UNITED STATES PATENT AND TRADEMARK OFFICE

Office Action Summary

10/789,120

BADER, THOMAS

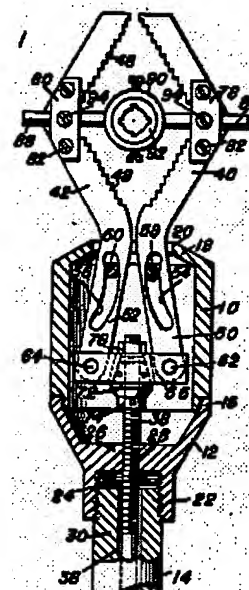
6. Claims 1, and 4-6 (as best understood) are rejected under 35 U.S.C. 102(b) as being anticipated by Stevens (2,704,003).

Stevens discloses all of the limitations of claim 1, i.e., a device (10, 40, 42) capable of being securable on a shaft supporting a tool bit for holding a bit insertable in the tool bit of a power tool comprising at least two clamping members (defined by 48 of 40, 42) displaceable upon application of a force (through rotation of crank 34) from a holding or support position to a release position and forming a front stop (tip of 46).

Regarding claims 4-6, Stevens meets the limitations, i.e., clamping arms (50, 52) supported by a pivot support (62, 64) displaceable by a slotted crank guide (54, 56); the guide having a curved recess and a guide member (58, 60) connected to the shaft (24, thru 12) and having curved first end in the support position.

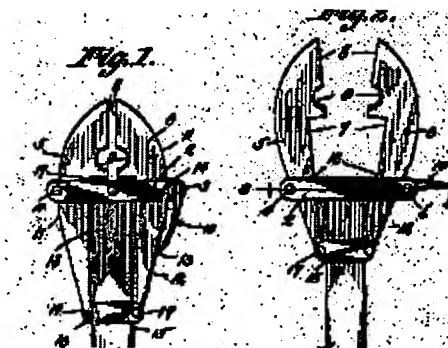
7. Claims 1, 10, and 11 (as best understood) are rejected under 35 U.S.C. 102(b) as being anticipated by Beaver (1,623,379).

Beaver discloses all of the limitations of claim 1, i.e., a device (2, 5, 6, 15) capable of being securable on a shaft supporting a tool bit for holding a bit insertable in the tool

bit of a power tool comprising at least two clamping members (defined by 9 of 5, 6) displaceable upon application of a force from a holding or support position to a release position and forming a front stop (tip of 8).

Regarding claims 10 and 11, Beaver meets the limitations, i.e., a locking device (10) and means for adjusting the locking position (12, 13). Note that narrative/function language fails to further limit the device structurally.
